Intel[®] Pentium[®] III Xeon[™] Processor Specification Update

Release Date: November 2000

Order Number: 244460-022

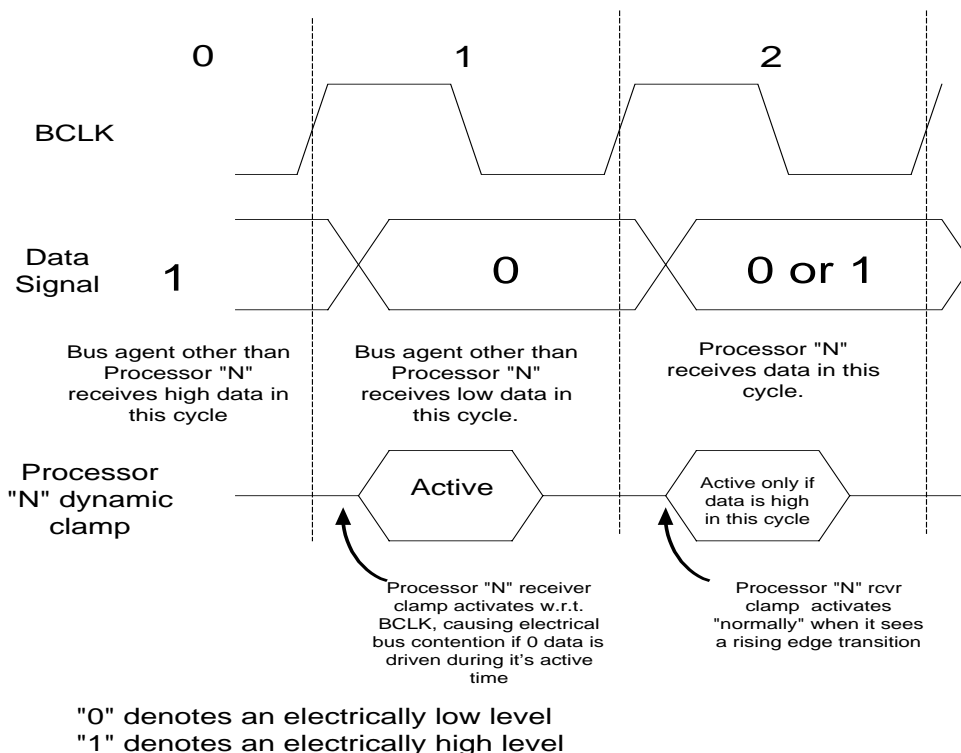
Workaround: The AGTL+ V_{REF} (input voltage reference) level will be raised from 1.0V to 1.1V (assuming a V_{TT} of 1.5V) on the processor cartridge substrate. This allows the dynamic clamp to activate at a trigger level approximately 100 mV higher than with the previous 1.0V V_{REF} setting. Due to the dependence upon system bus design, bus layout may be evaluated to determine the need for improvements in falling edge ringback levels. This may involve one or several of the following baseboard modifications:

1. Change termination resistor value to reduce multi-bit noise and/or improve V_{IL} noise margin.
2. Reduce multi-bit noise by improving ground return paths (additional high-frequency decoupling, improved AC plane referencing, etc.).
3. Raising or lowering the V_{TT} level (within the AC & DC tolerances specified in the processor EMTS) to improve V_{IL} noise margin and/or reduce the multi-bit noise due to dl/dt transients.

Stress tests using various data patterns and transactions should be run to identify the worst-case multi-bit noise conditions for this erratum.
